CUSTOMER ADVISORY

ADV2002

Label Content Update for FPGA and Power Products

Table 2: Label Sample with “RoHS COMPLIANT”

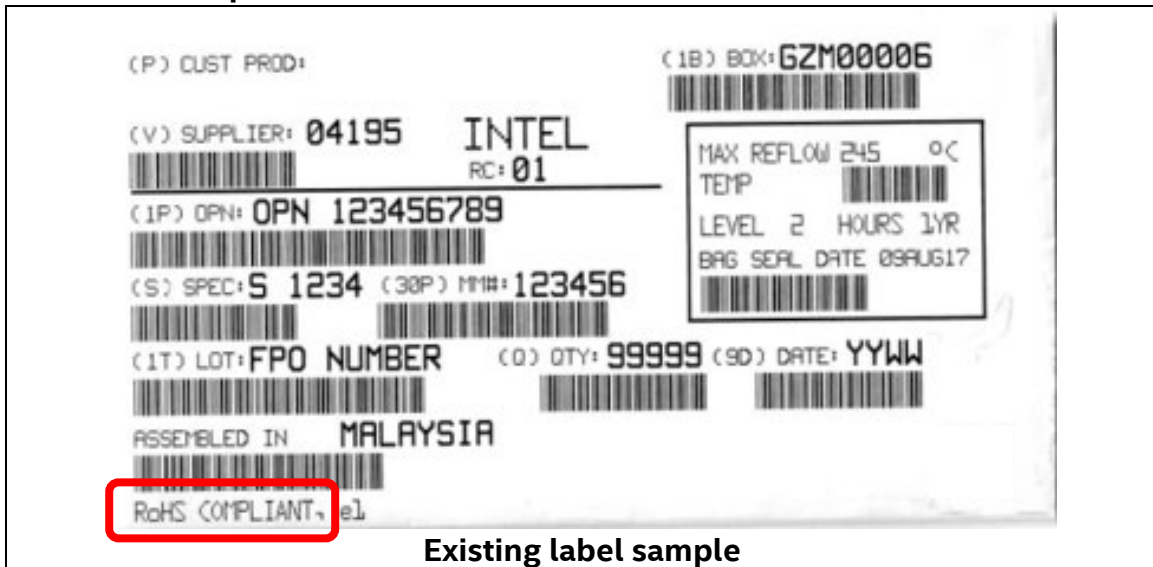
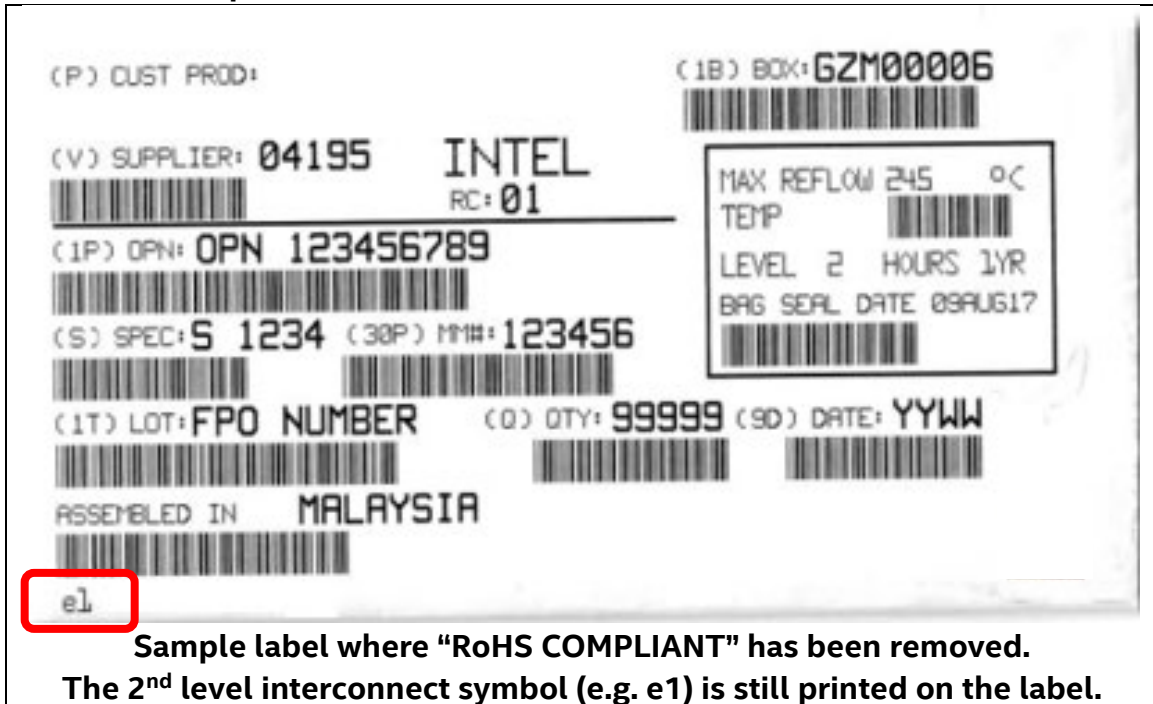
Change From	Change To
"RoHS COMPLIANT" indicated on the lower left of the barcode label	Labels may or may not indicate " RoHS COMPLIANT " on the barcode label. The 2nd level interconnect symbol (e.g. e1) remains printed on the label.
